Access Compliance Report

Public Rights-of-Way

Intersection ID: 21312	Main Street: E_ARROWOOD_RD	Cross Street: SOUTH_BV	Location: NW
ADA ID: 63DF52373045	Ramp Type: PerpDiag	Initial Pass/Fail: Fail	Overall Compliance: No
Severity Score: 26.25			
Codes/Mitigation Info/Possible Solution		Field Measurements/Component Compliance

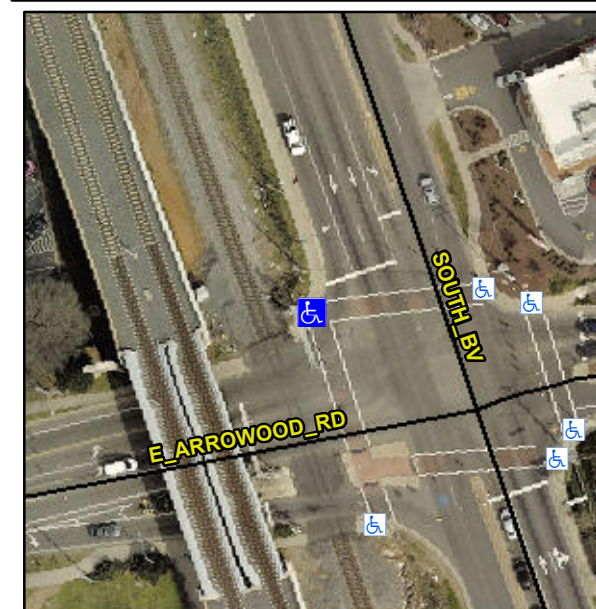
R304.2.2, R304.5.3

Compliance	Description	Data	Compliance	Description	Data
N/A	Ramp Length (in)	48.0	No	Ramp Slope (%)	13.5
Yes	Ramp Width (in)	96.0	No	Ramp XSlope (%)	3.8
N/A	Flare Type LT	N/A	N/A	Flare Type RT	N/A
N/A	Flare Slope LT (%)	N/A	N/A	Flare Slope RT (%)	N/A
N/A	Flare Traversable LT?	N/A	N/A	Flare Traversable RT?	N/A
N/A	Landing Length (in)	N/A	N/A	DWS Provided?	N/A
N/A	Landing Width (in)	N/A	N/A	DWS Contrast?	N/A
N/A	Landing Slope (%)	N/A	N/A	DWS Length (in)	N/A
N/A	Landing X Slope (%)	N/A	N/A	DWS Full Width?	N/A
N/A	Landing Curb? (Y/N)	N/A	N/A	DWS Offset (in)	N/A
N/A	Shared Landing?	N/A			
N/A	Gutter Ponding?	N/A	N/A	Gutter Slope (%)	N/A
N/A	Gutter Lip Ht (in)	N/A	N/A	Gutter X Slope (%)	N/A
N/A	Painted X Walk1?	Yes	N/A	Painted X Walk2?	Yes
	X Walk 1 Direction	To S		X Walk 2 Direction	To E
N/A	X Walk 1 Width (in)	127.0	N/A	X Walk 2 Width (in)	124.0
	X Walk 1 Slope (%)	2.2		X Walk 2 Slope (%)	2.9
	X Walk 1 X Slope (%)	3.6		X Walk 2 X Slope (%)	1.8

Remove & Replace Curb Ramp With Two New Directional Ramps or Equivalent.
